Thames Farm Action Group

Representations re: Amended Planning Applications P24/S2642/FUL,
P24/S2652/S73, P24/S2651/DIS Submitted 09/01/2025

JBA Project Code	2023s1304
Contract	Thames Farm Planning Application
Client	Thames Farm Action Group
Date	February 2025
Author	Dimitrios Goukos, Benjamin Brière De L'Isle
Reviewer / Sign-off	Paul Eccleston
Subject	Review of updated evidence submitted in January 2025.

Figure 4-2: Mapped voids, 2019 geotechnical investigation © Terramech

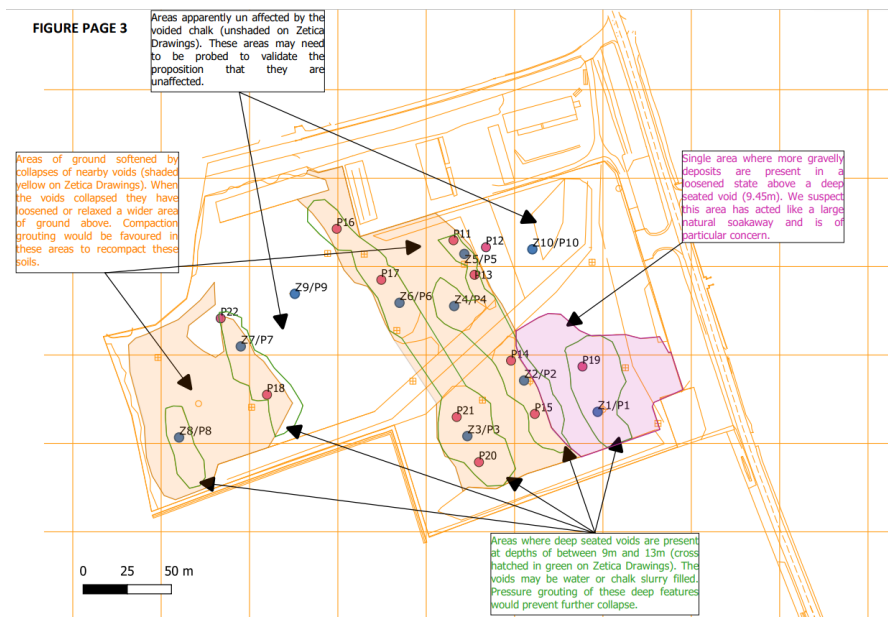
The same conclusions were reached by the 2019⁹ Terramech Ground Investigation, as shown in Figure 4-2. It is not coincidental that Terramech's Ground Investigation utilises Zetica's map of deep voided ground in the chalk and shallow relaxed ground, as their conclusions coincide.

2019 Terramech GI, as shown in Figure 4-2, suggests that "Areas of ground softened by collapses of nearby voids (shaded yellow on Zetica Drawings). When the voids collapsed they have loosened or relaxed a wider area of ground above. Compaction grouting would be favoured in these areas to recompact these soils" and "Areas where deep seated voids are present at depths of between 9m and 13m (cross hatched in green on Zetica Drawings). The voids may be water or chalk slurry filled. Pressure grouting of these deep features would prevent further collapse".

2019 Terramech's GI referring to the above figure, mentions that "The plan shows the five linear deep seated voids stretching across this site outlined in green and the loosened or relaxed areas shaded orange or purple. Collapsing of the deep seated voids has already affected large areas of the site and the potential for underground collapses to migrate to the surface has been proven by the appearance of two swallow holes.

Figure 4-3: Interpretative layout plan © Vertase FLI

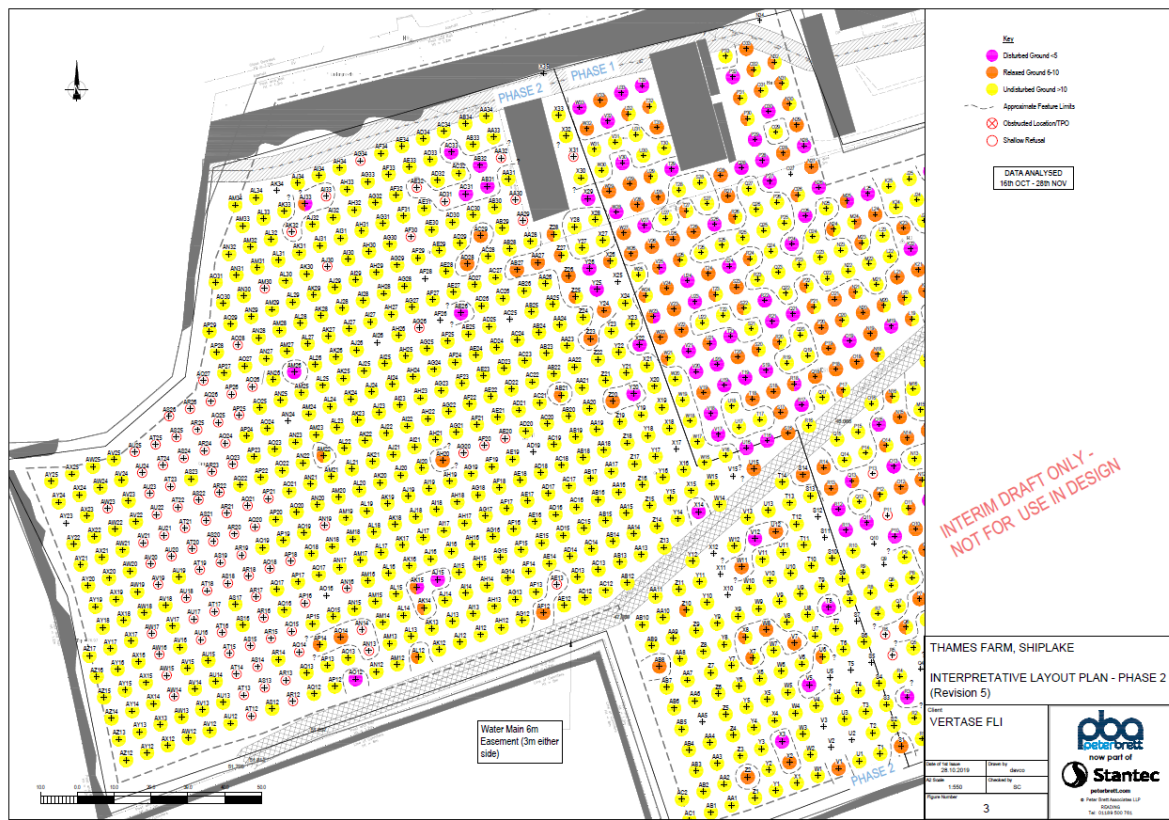
Figure 4-5, which argues that the soil beneath the area where the basin sits has no deep voids in the chalk and is not an area of shallow relaxed ground, appears to be based on an interpretation of the 2020 Stantec¹¹ (On behalf of Vertase FLI Ltd) "Ground Stabilisation by Compaction Grouting Specification", where a considerable portion of the implemented dynamic probe results, of the area where the infiltration basin is planned to lie, were characterised as "Shallow Refusals" (Figure 4-3), denoting that probing did not proceed to the planned depths due to encountering significant resistance at shallower depths. Nevertheless, these areas have been interpreted in the drilling and grouting plan as areas not requiring any intervention.

The same document mentions that "As discussed in Section 5.2.3, there is an area towards the west of the site where ground conditions are currently undetermined after 66 no. locations recorded shallow refusals, likely associated with large flint cobbles. Due to the size of this area and the understanding that dissolution features may be present in this area, it is recommended further investigation, through the use of rotary or cable percussive boreholes is carried out to confirm the ground conditions in this area", and continues "The adoption of the infiltration drainage at this site will need to take into consideration the ground conditions identified in this report. Shallow soakaways are not recommended for drainage discharge into the ground because of the potential for destabilising existing solution features.

Where the ground is scheduled to be stabilised, consideration should be given to the depth of drainage discharge below the zone of treatment, for example, by means of deep bore soakaways. Infiltration drainage at the site should be undertaken in accordance with CIRIA C574, and any testing required, for example soakaway testing, or falling and maintained head infiltration tests, should be carried out in accordance with Building Research Establishment DG 365 and BS 5930:2015 respectively".

Figure 4-4: August 2024 drainage layout plan 4 © Taylor Wimpey

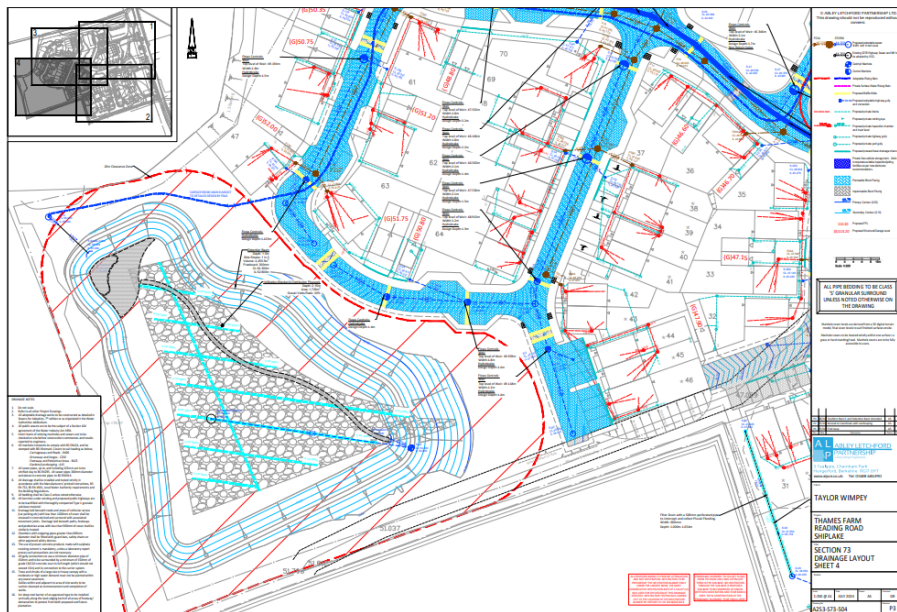
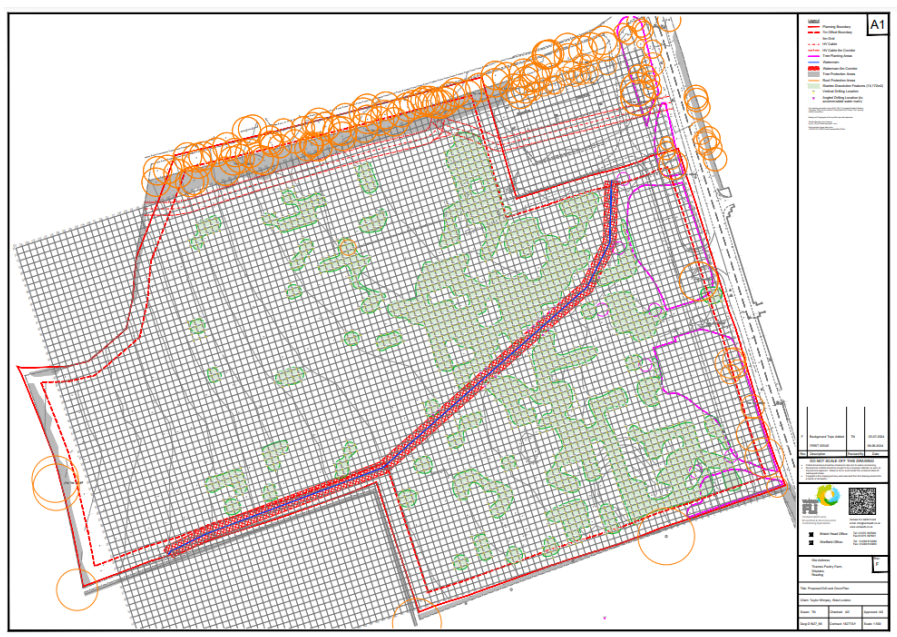
The deep-seated void area in the western part of the site coincides with the proposed location for the infiltration basin (Figure 4-4¹⁰). However, the 2024 drilling and grouting plan (Figure 4-5⁷) shows only minimal works in this area.

Considering the above it is evident that the 2024 proposed drainage system's sole disposal feature (the upper infiltration basin) is potentially sitting above an area of a deep voided ground in the chalk and shallow relaxed ground. Therefore, explanation is required as to the reason for limited grouting works in this area, and for not having undertaken the further investigations using rotary or cable percussive boreholes as recommended in the 2020 Stantec report. When storing up to 1.5m (basin) + 3.6m (infiltration blanket) of water, there would be significant ground loading and potentially rapid scour of existing voids if these are not stabilised prior to construction of the basin. If they are treated, as discussed above, the infiltration rate needs to be adjusted, and preferably reconfirmed after the grouting works, to ensure that it is adequate to safely discharge the site's surface water to the ground.

- The infiltration rate applied to the upper basin needs to be reassessed if compaction and/or grouting works are planned within the basin's footprint. The latest design does not account for any potential loss of infiltration capacity as a result of compaction and/or grouting. The surface water drainage of the whole site relies upon the ability of this basin to effectively infiltrate.
